Response to reviewer 1

Response to reviewer 2

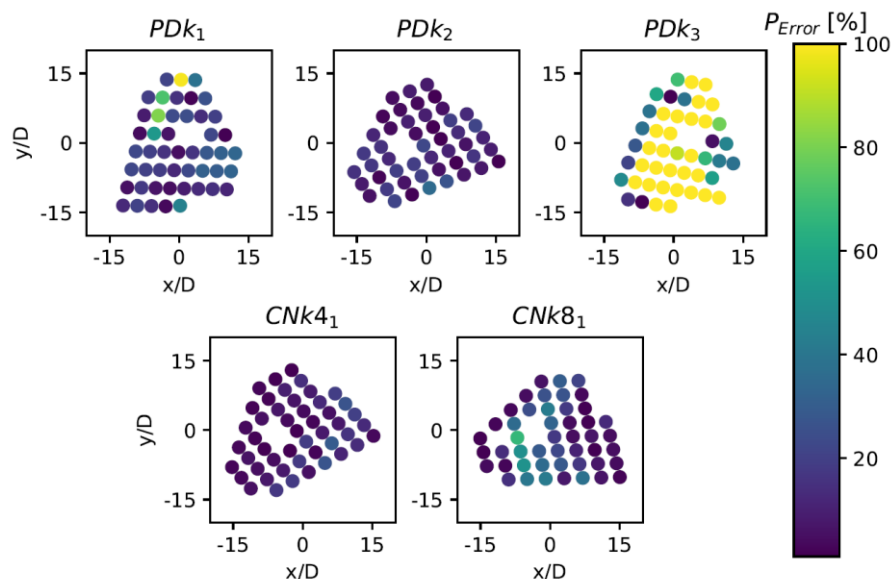
20. Section 4.2: Overall, I find this section and the outlined approach interesting. I recognize the technical challenges of what the authors are attempting, given fundamental inconsistencies between the CN or PD LES cases and the true ABL LiDAR measurements. Primarily, fitting neutral or PD ABL profiles to non-neutral ABLs may bias the results. So, I suggest the authors add an additional paragraph, addressing the following:

- a. Discussion of the stability during the LiDAR measurement time periods.
 - b. Discussion of how the optimization process which finds the minimum error compared to conventionally neutral or pressure driven boundary layers (with no stratification) may bias the considered cases.

- c. Given the poor agreement in the wind veer, discuss how the optimization process may have biased the results to over-emphasize wind speed compared to wind direction.

- d. Discussion of how the pronounced disagreement between LiDAR and LES above the rotor area may bias the vertical transport into the wind turbine array atmospheric boundary layer (WTABL).

We thank the reviewer for the suggestion and have now included an additional section 4.3 to acknowledge these shortcomings and sources of error. We agree that stability conditions at the Lillgrund site would have a significant effect on wind farm performance and the resulting errors in LES. However due to a lack of stability information during the measurement campaign, we were unable to include this in our methodology for recreating the inflow conditions. This has been summarized as below in section 4.3

“The developed optimization framework is therefore able to successfully recreate the inflow conditions at the Lillgrund wind farm for the chosen time periods, without significant errors in the mean inflow velocity across the rotor area, as evident by Figure 9. However, a few shortcomings of the optimization framework must be addressed. Atmospheric stability and stratification can play a significant role in the performance of a wind farm by affecting wake recovery and ambient turbulent intensity (Magnusson and Smedman, 1994). Additionally, due to the close land proximity of the Lillgrund wind farm, the atmospheric conditions at the farm can be significantly affected by a land–sea system as a combination of marine and land boundary layers. The current methodology does not take the meso-scale effects at the Lillgrund site into account, instead relying on a database comprising of marine pressure driven and neutral boundary layers to match the inflow conditions. This is due to the lack of atmospheric stability and temperature measurements at the Lillgrund site during the measurement campaign. If the data was available, the inflow database used could have been modified before the transformation procedure to consist of precursor boundary layers which best represent the stability conditions at the wind farm site. In its current form, the considered cases may be biased as they are chosen simply based on minimum error in the distance metrics and do not account for stability or land–sea effects. Additionally, without the inclusion of appropriate weights or additional distance metrics to penalize wind veer error, the current procedure may have been biased to overemphasize mean speed error as compared to wind veer error. The error in the LiDAR and LES velocity profiles above the rotor area could also affect the vertical transport into the wind turbine array atmospheric boundary layer (WTABL), which may affect the overall wind farm performance (Calaf et al., 2010).”

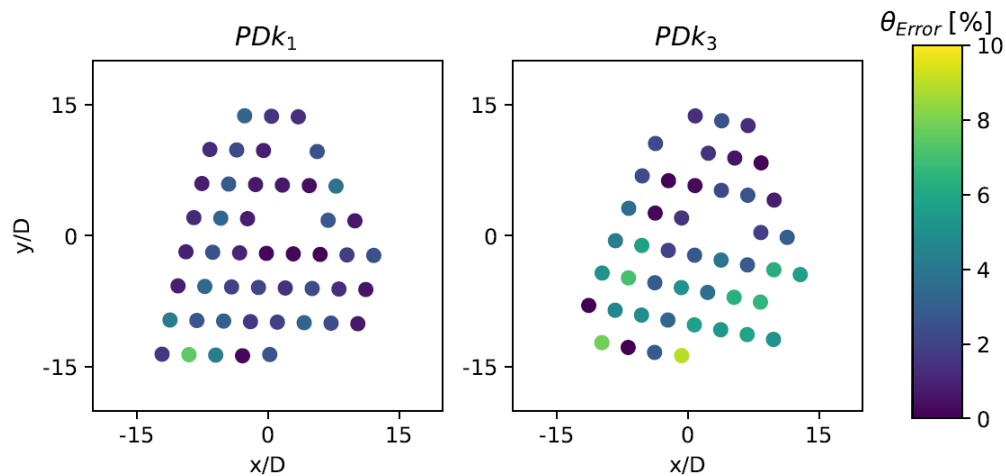
21. Line 286: “This is in accordance with the errors in the inflow profiles observed [...]” The analysis of the power results in this sentence appears weak and selective. First, putting aside the power and looking just at the wind profiles in Figure 8, all of the PD cases have high error in the wind veer, not just PDK3. Second, it is not clear from Figure 8 that the PD cases have lower wind speed error than the CN cases. For example, CNk8 seems to have fairly low wind speed and wind veer error. Cases PDK1 and PDK2 do not appear to have significantly lower wind speed error compared to the LiDAR than CNk8. The authors should revisit this analysis with more attention. I suggest quantitative metrics to support the statements.

We thank the author for this remark, and revisited the error analysis with more attention. Upon further investigation, we discovered that the main influence on the power errors observed are due to the wind direction and the waked/un-waked state of the wind turbine. From the below figure, it can be seen that the turbines operating right behind the first turbines exhibit the highest power errors, while turbines operating in un-waked or towards the back of the farm exhibit lower errors. This indicates a difference in wake recovery in LES and the field measurements which is further confirmed in the wake recover analysis. The errors could be due to a difference in stability, the high errors above the rotor in the developed inflow boundary layers, or differences in meso-scale effects which can cause wind direction changes across the farm as is evident from the newly added figure 16. The higher power errors for the PDK3 case can also be attributed to a difference in controller at the low wind speed regime, where the PDK3 turbines within the farm are exhibiting high pitch angles and operating in a start-up regime with negligible power production, which is not happening for our turbines in the simulation environment. We have now included the following figure and a new paragraph in section 5.3 to discuss this.

Figure 20. Comparison of far wake velocity wake deficit at downstream locations from turbine C06 for the case *CNk4₁*. Line at $y/D=0$ is perpendicular to the turbine orientation from SCADA data. Shaded area represents 95% confidence interval on the mean.

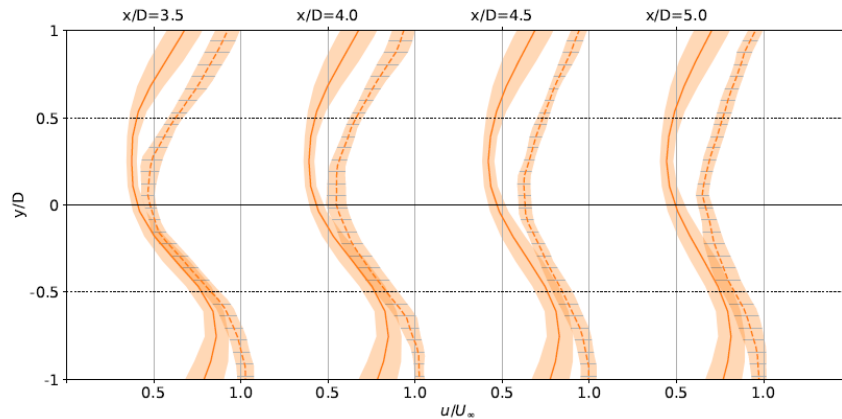
29. Figures 16 and 17: Why is the far wake comparison omitted from these plots? Please include. They are mentioned on line 335, so presumably the data is there. If they were selectively omitted due to poor agreement between LES and LiDAR, that is even more reason to include them in the figures.

A far wake analysis has now been included for the CNk4_1 case. This was not possible for the PDK_1 case as far wake lidar data was not available. The wake deficit figures have also been updated to include confidence intervals for the LES data.
